EXHIBIT 33
Architectural Plans
Rear Landing and Stairs

Subject: Architectural Planning Drawings for Case No. 21316

ALTERATION / ADDITION
515 21 st STREET, NE
WASHINGTON DC

AE-1

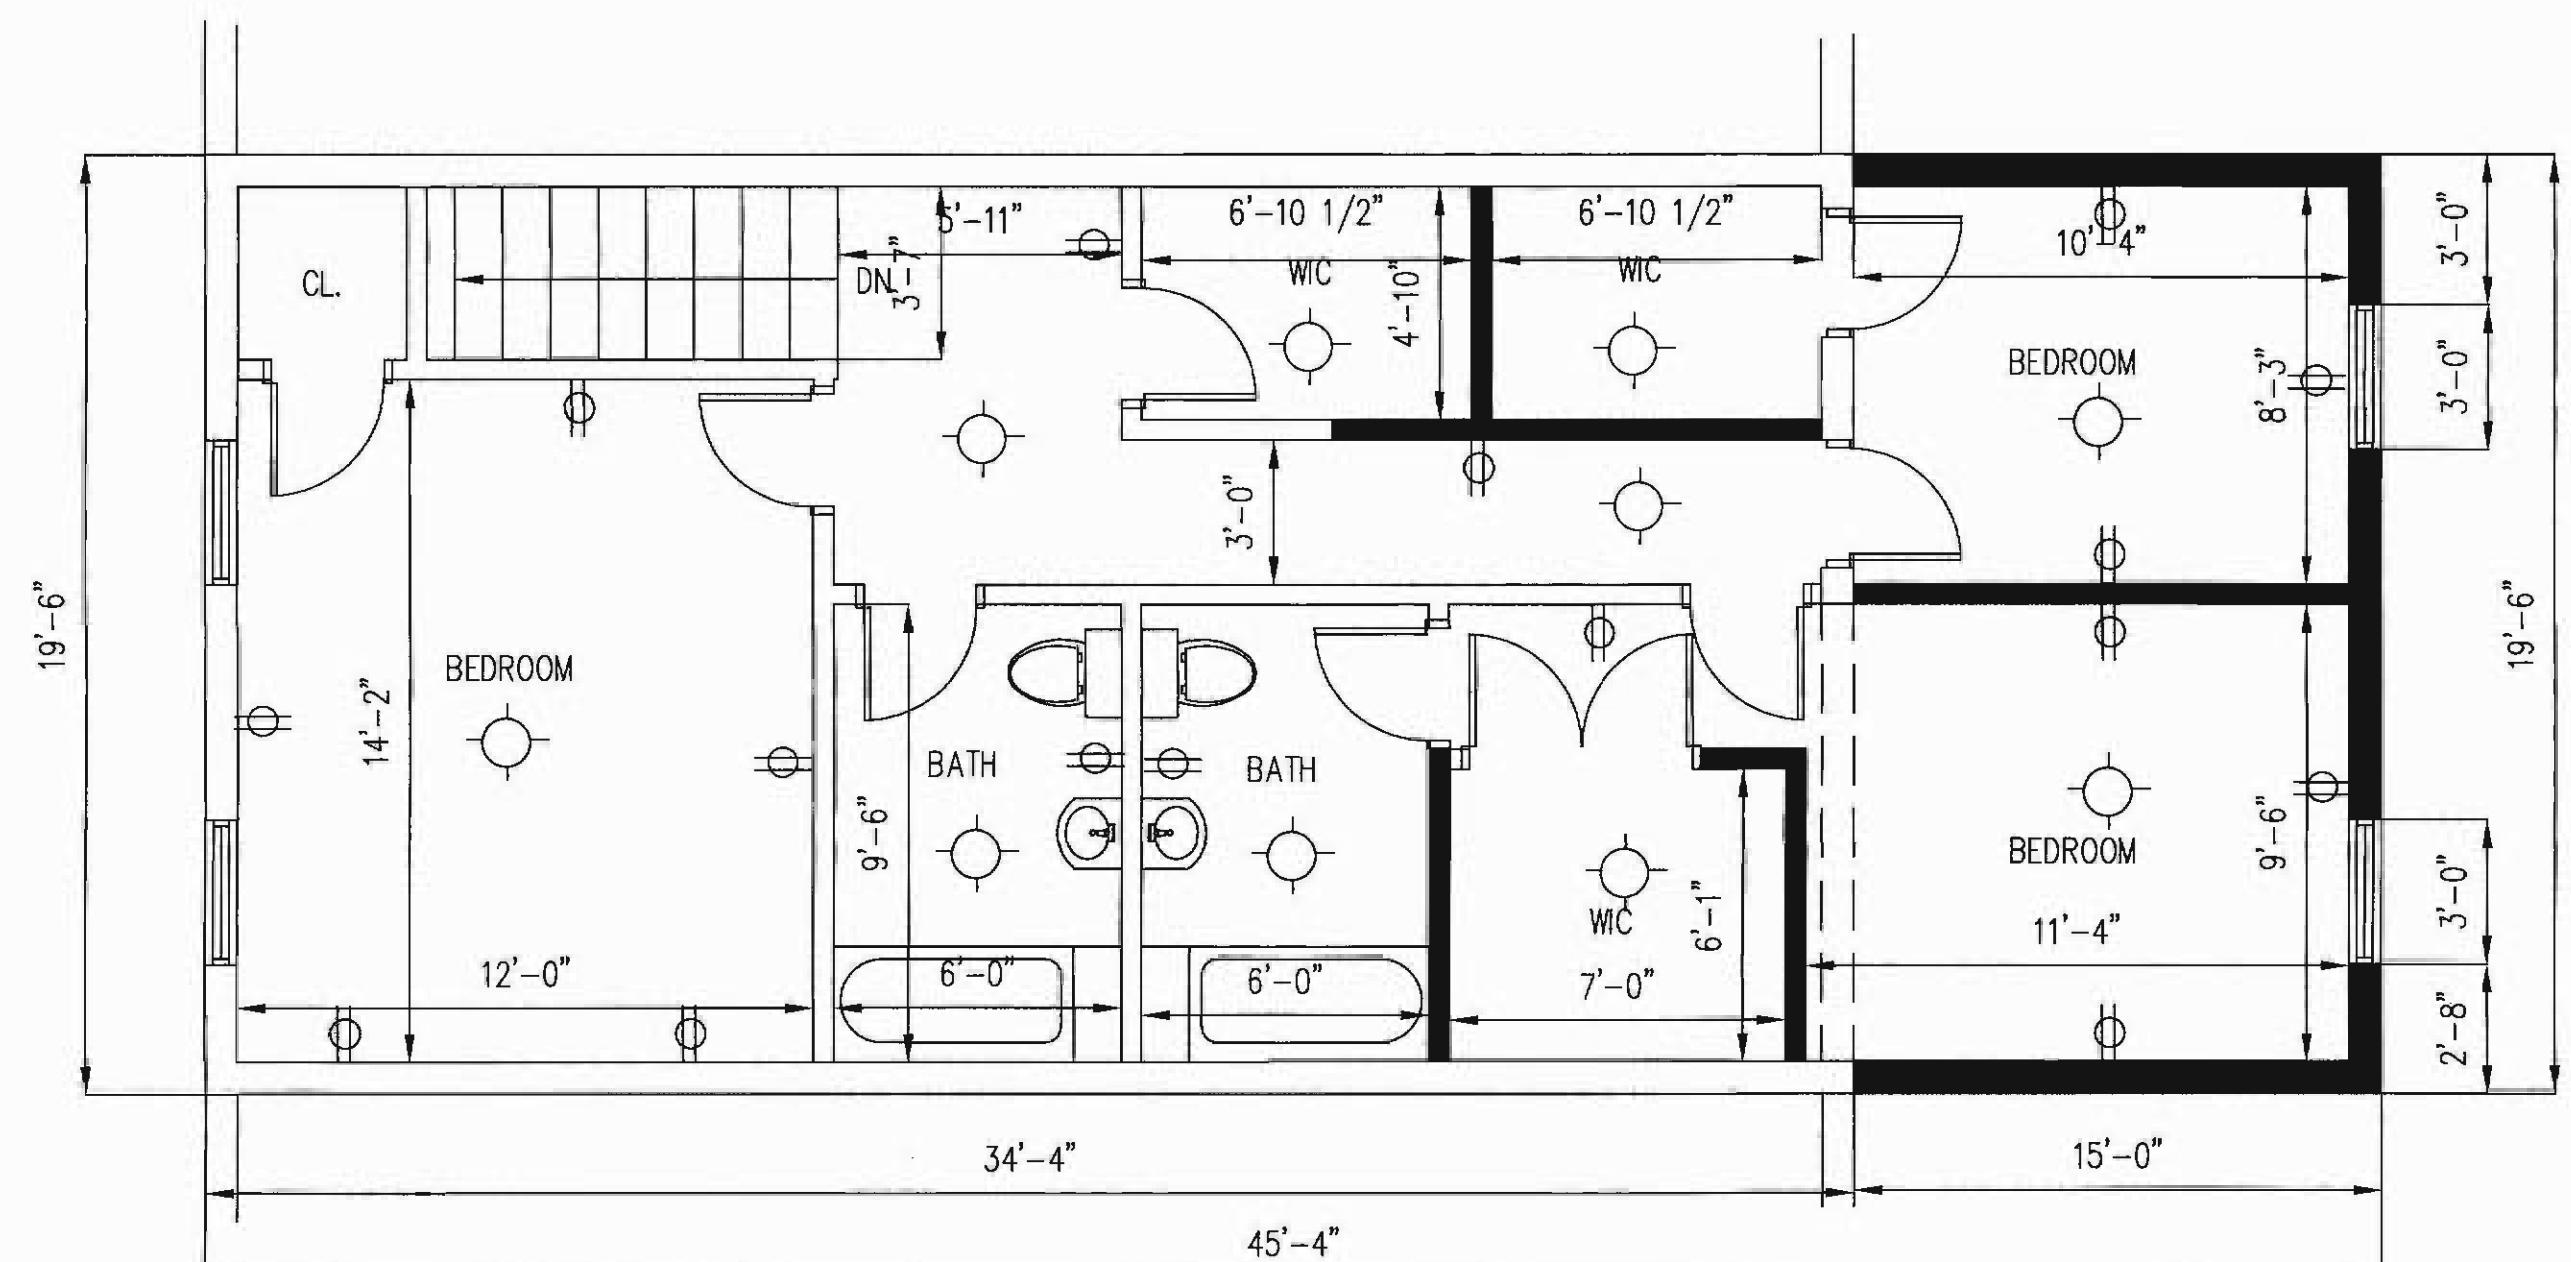
At the request of the Board, we have prepared this Architectural Planning Drawing illustrating our client's plan for ingress and egress to the rear exit of 515 21st St. N.E. Please note that the original plans submitted (Exhibit 12D, page 1) illustrate a French Door with protective railing only. Exhibit 33 now shows the plans for a small landing with stairs and a railing down to the rear yard.
